Access Compliance Report Public Rights-of-Way (Curb Ramps)

Main Street: ANDAZA_ST Cross Street: ESENCIA_DR Location: E

ADA ID: RPRK211129122712 Ramp Type: Type 1 - Perpendicular Initial Pass/Fail: Pass Overall Compliance: No Severity Score: 0

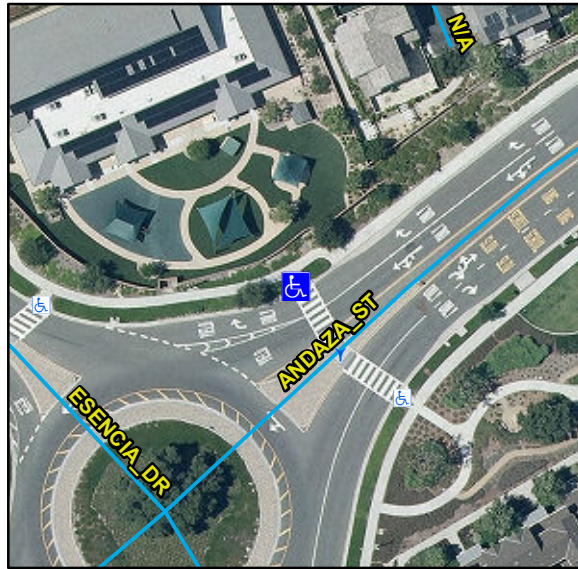
R304.2.2, R304.5.3, STD 1115

Yes	Ramp Inside Crosswalk 1	Yes	Yes	Ramp Inside Crosswalk 2	N/A
	Crossing 1 Slope (%)	2.1		Crossing 2 Slope (%)	N/A
	Crossing 1 Cross Slope (%)	2.6		Crossing 2 Cross Slope (%)	N/A
Yes	Gutter Ponding	No	No	Curb Slope	12.3
Yes	Gutter Lip Height (in)	0		Road Run Slope (%)	N/A
Yes	Gutter Run Slope (%)	4.9		Road Cross Slope (%)	N/A
Yes	Gutter Cross Slope (%)	2			
Yes	Overall Surface Condition: Acceptable		Yes	Perp Joint Present	Yes
	Cross Gutter Present?	No		Spandrel Present?	No
	Replace Cross Gutter?	N/A		Replace Spandrel?	N/A

Remove & Replace Entire Ramp.
